## AGENDA ITEM EXECUTIVE SUMMARY

| Title:        | Recommendation to approve the 2013 Comprehensive Plan |

**2013 Comprehensive Plan Draft Review Discussion Points and Recommendations**

### Charlestowne Mall Framework Plan

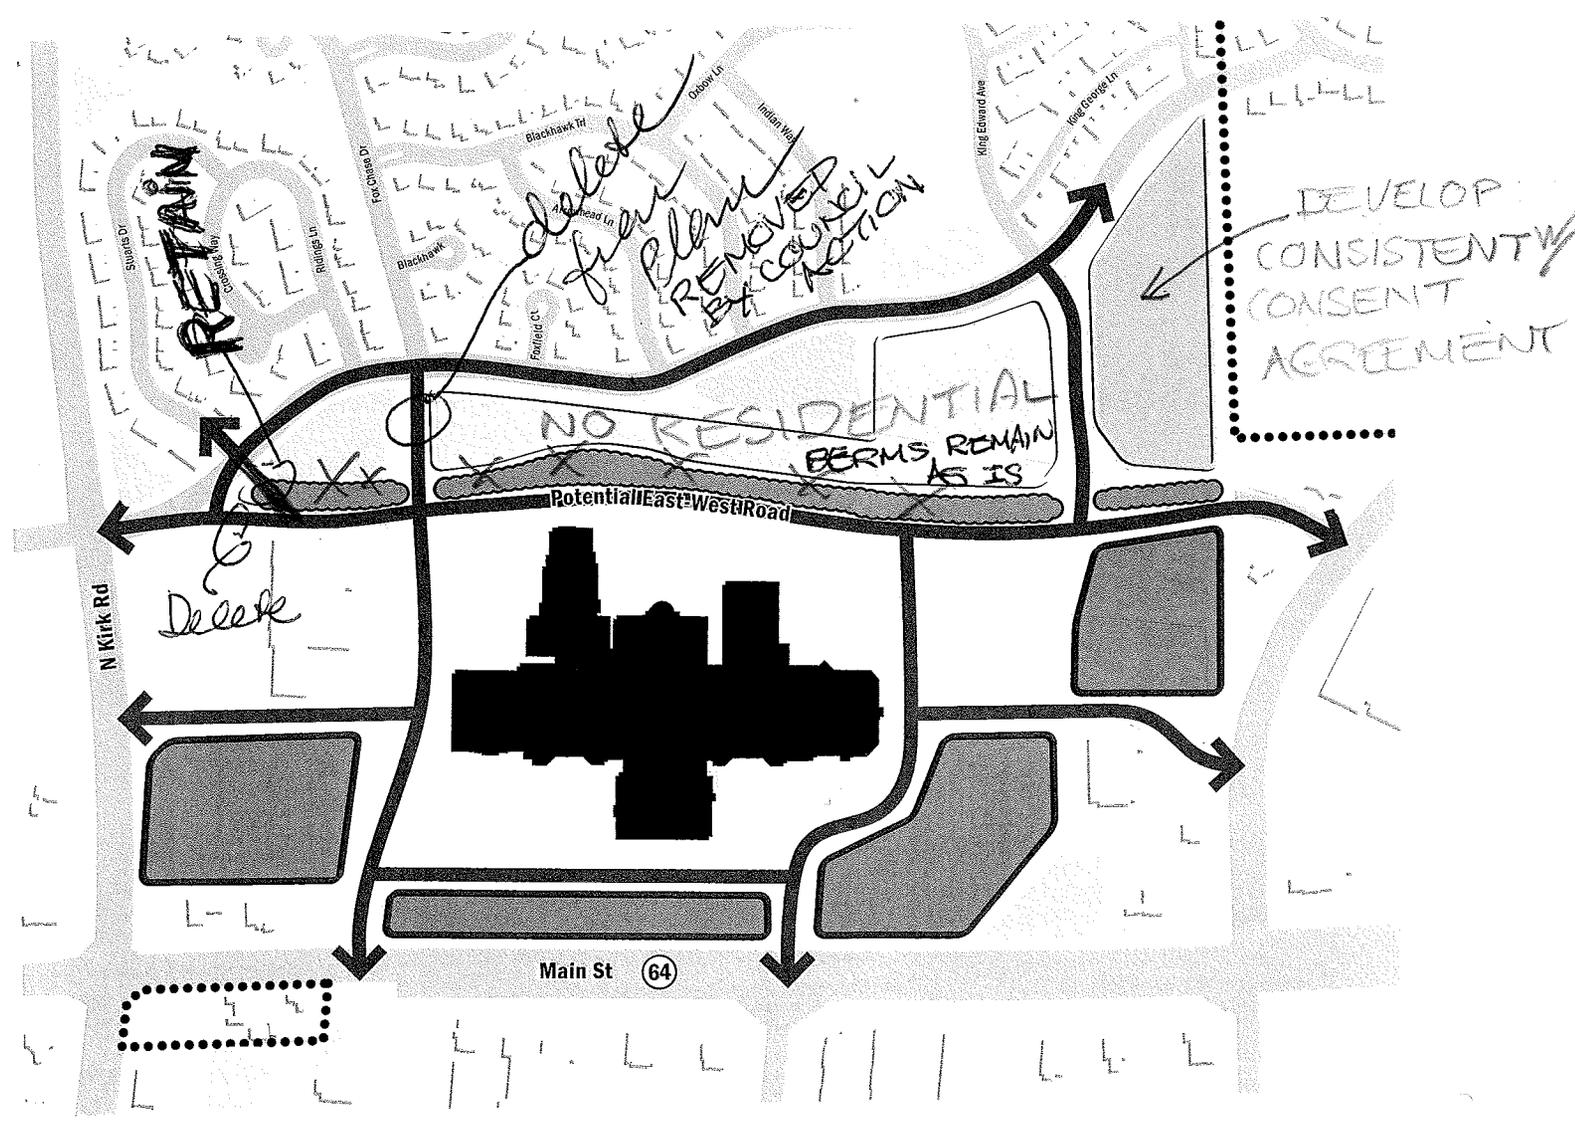
|     | <u>Chapter/Page/ Topic</u>  | <u>Comment/Question</u>  | <u>Response/Follow Up/Discussion</u>   | <u>P&amp;D Committee Recommendation</u> |
|-----|---|--|--|---|
| 11. | <p><b>Charlestowne Mall Framework Plan</b></p> <p>Ch. 8 East Gateway Subarea, p. 83</p> | <p>The Committee approved a motion to “remove residential from both the St. Charles Mall site and Charlestowne Mall.”</p> <p>Specifically, the Committee discussed:</p> <ul style="list-style-type: none"> <li>• Removing residential uses located over the stormwater basins at the north end of the mall property</li> <li>• Showing land uses on the Oliver-Hoffmann site consistent with the Consent Decree for the site.</li> </ul> | <p><u>At a minimum, the following changes to the Framework Plan on p. 83 would be necessary:</u></p> <ul style="list-style-type: none"> <li>• “Single Family Residential” will be removed from the plan. Stormwater basins on the north side of the mall site will be shown on the plan. The screening buffer north of the Mall can be shifted further north to the Mall property line.</li> <li>• The northwest section of the Oliver-Hoffmann site will be shown as “Outlot Commercial, Retail and Office Development”, consistent with the other sites around the mall building.</li> </ul> <p><u>Change to citywide Land Use Plan on p. 30:</u><br/>Revise the Land Use Plan to match the revisions to the Charlestowne Mall Framework Plan.</p> <p><u>Other change to consider:</u><br/>P. 34, 36, 40: These pages reference “potential mixed use” for the Charlestowne Mall site, but recognize the future land use designation of the site is “Corridor/Regional Commercial.” This can remain as is or be removed to eliminate any reference to mixed use at this site.</p> |   |

To confirm comments in my e-mail *Carl Jenke*

TO ATTACH ITEM IN LIST OF CHANGES Chapter 8 Subarea Plans
